DA No: 2021/1841

DEMOLITION WORKS AND CONSTRUCTION OF A SENIORS HOUSING DEVELOPMENT.

7 & 8 CORONATION STREET, MONA VALE

Figure 1 – EXISTING VIEW – LIVING / BALCONY – PRINCIPAL DWELLING

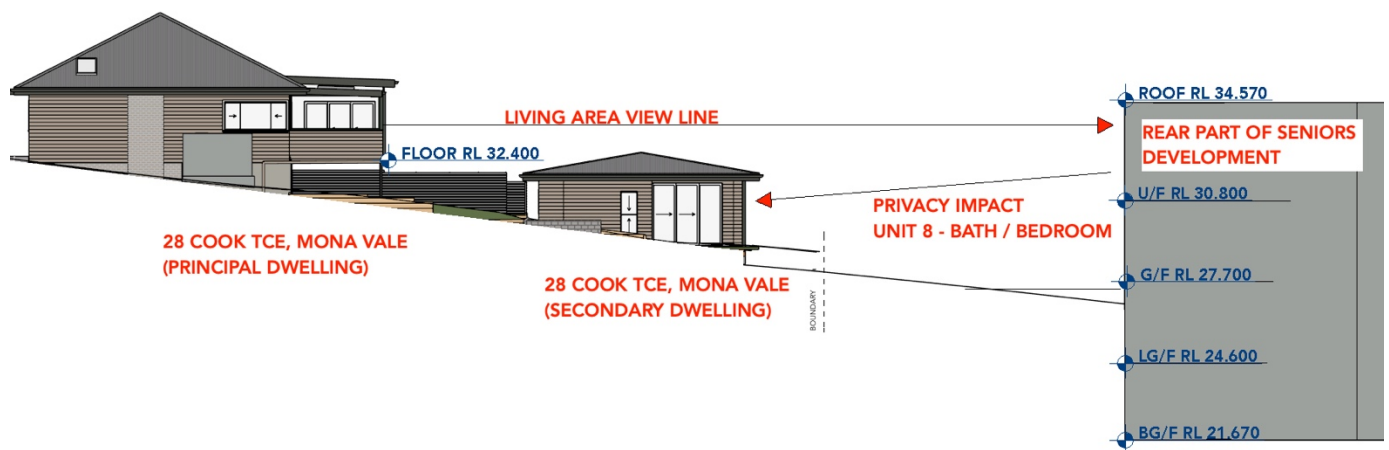
Properties located in Cook Terrace, No's 28, 28a, 30, 32, are existing 1 and 2 storey detached dwelling houses which are orientated to the north to take advantage of solar access, prevailing breezes and views across Mona Vale Golf Course to the Mona Vale basin, Pittwater waterway basin, headland/foreshore to the north west, north and north east.

A view analysis has not been provided with the application, to indicate views currently available when view from Cook Terrace properties or the likely impact of the proposal on such views. There is insufficient information on how the proposal seeks to achieve equitable view sharing and view retention.

Given the built form of the proposed development and the span of potential impacts across Cook Terrace properties, height poles are requested to be erected to determine likely impacts to views and compliance with Clause C1.3 View Sharing of Pittwater 21DCP.

Figure 4 – PRIVACY IMPACT VIEW LINE – SECONDARY DWELLING

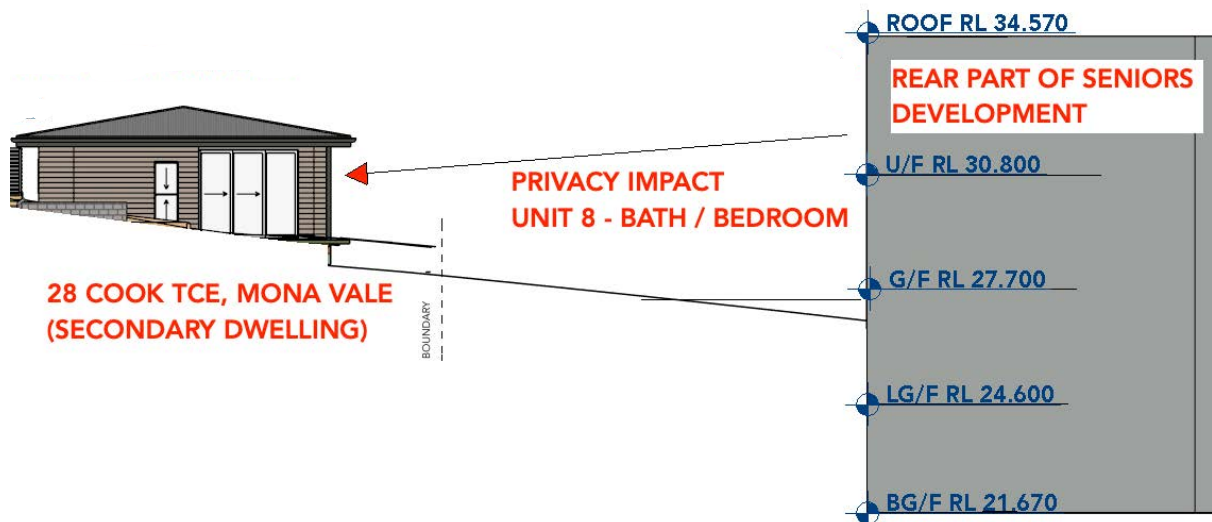
The upper floor level of the development (unit 8 - RL 30.80) are proposed 1800mm higher than the existing rear secondary dwelling floor level of RL 29.00 located 3 metres from the rear boundary.

The increased floor height together with the windows proposed in the southern wall of the bathroom & bedroom will enable direct viewing into the living

rooms and private open space area of the rear secondary dwelling of our property. All overlooking occurs from an elevated viewing angle. To address these privacy issues, we consider the following amendments should be enforced by Council:

1. Fixed obscure glazing or a highlight window to the bathroom and bedroom windows to a height of 1.7 metres above the floor level respectively.

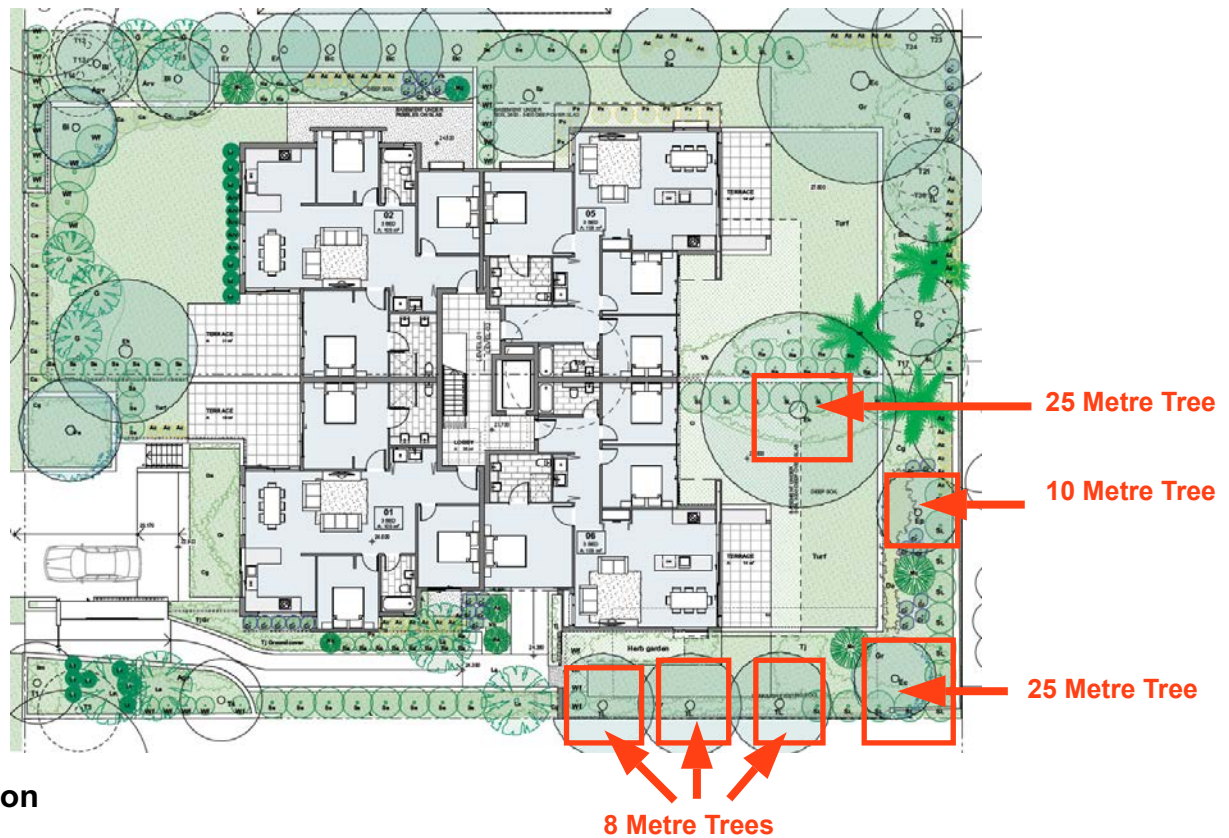
The landscape plan (see below extracts highlighted in red) shows new trees from 8 metres to a height of 25 metres to the rear of the development. These proposed tree sizes and locations will have a detrimental impact on current available views & access to sunlight from Cook Terrace properties. We request the landscape plan be amended to lower tree heights to no more than 4 - 6 metres to maintain equal sharing of views & prevent overshadowing of private open spaces into the future, in the likelihood of any approval.
